RE: Feedback of Renewable Northwest, 2021 IRP Webinar 13

Puget Sound Energy's March 5, 2021, Webinar Relating to the Stochastic Analysis, Resource Plan, and Clean Energy Action Plan for the 2021 Integrated Resource Plan.

RE: Comments of Renewable Northwest, Docket UE-200304

Figure 8-12: Net Cost of Capacity in the Portfolio Model

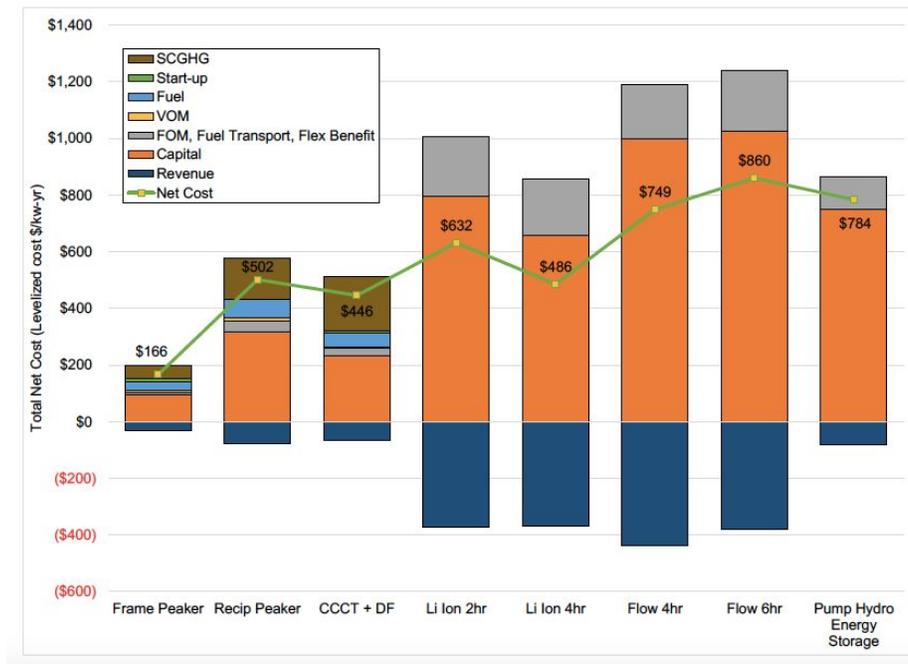
PSE provides a levelized cost of capacity comparison for peakers, baseload gas plants, and energy storage resources in the Mid Scenario, illustrated by *Figure 8-12* in the Draft IRP:

However, public data and other IRP filings support lower capital cost estimates (\$/kW) than PSE has incorporated in their modeling. For example, the National Renewable Energy Laboratory’s (“NREL”) 2018 Annual Technology Baseline (“ATB”) reports meaningfully lower costs for 2-hour and 4-hour lithium-ion batteries with mid-cost projections (shown in *Figure 1* below). The most recent cost estimates reflected in NREL’s 2020 ATB are lower still at \$1500/kW for a moderate-level projection (shown in *Figure 2* below). On the other hand, the 4-hour Li-ion battery capital cost assumed for the “Levelized Capacity Cost” (in PSE’s Figure 8-12 reproduced above) calculation would produce a range of 2300-2400 kW/year, assuming a 15-year system lifecycle and a capacity credit of 25% -- a very conservative estimate. Battery storage costs are falling rapidly and efficiencies are increasing due to technological advancements and economies of scale. Battery storage systems are increasingly emerging as important assets for the future grid -- and even the present grid -- to integrate increasing penetrations of non-emitting resources. Thus, evaluating their cost and operating parameters appropriately in the current IRP cycle would not only meet the company’s obligations this IRP cycle but also lay important groundwork for future resource planning.
